TAYBRE DRIVE SUBDIVISION PLAN

SB# 03-25 STAFF REPORT

October 22, 2025

PURPOSE OF PLAN: to consolidate Map 138/Lots 082 & 088 into one lot, known at map 138/Lot 088, and to depict the subdivision of Map 138/Lot 088 into nine (9) single-family residential lots, with all associated improvements.

Pond 29P: Basin 1

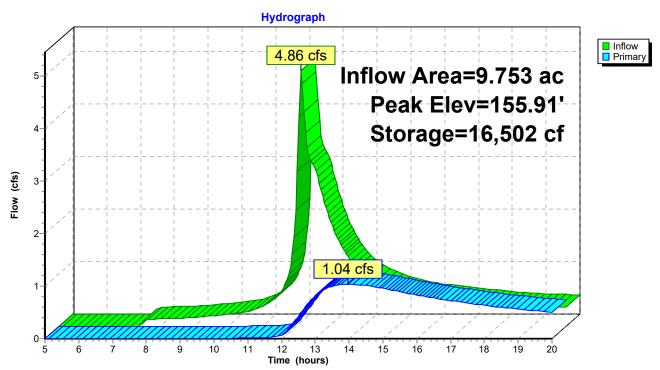
j. Former Fuss & O'Neill Comment: HR 290-5.A.11. The applicant should provide elevations for the Basin 1 weir elevations on Plan Sheet D-5.

Current Fuss & O'Neill Comment: The applicant has provided a weir detail on Plan Sheet D-5. The HydroCAD notes a "V Notch" to have a 1.5' height with a 1.5' width, while the Concrete Weir Outlet on

Plan Sheet D-5 depicts the "V Notch" to have a 1.35' height and 1.75 width. The applicant should coordinate the HydroCAD and detail accordingly.

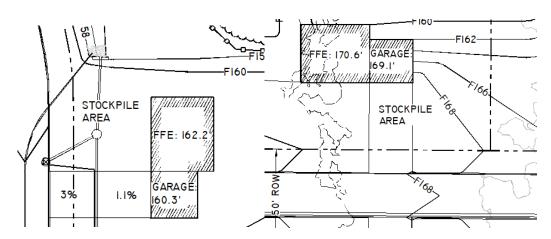
Former Fuss & O'Neill Comment: ETGTD Section 830.1.1. The applicant is proposing "diameter water service pipe. The standard requires 1"minimum. Also, the service connection detail shows a 2" water service pipe.

Current Fuss & O'Neill Comment: The applicant has revised the service size in the plan notes. We continue to recommend the labeling of the detail be revised from 1 - 2"service to say 1"service.

This has been changed to be 1".
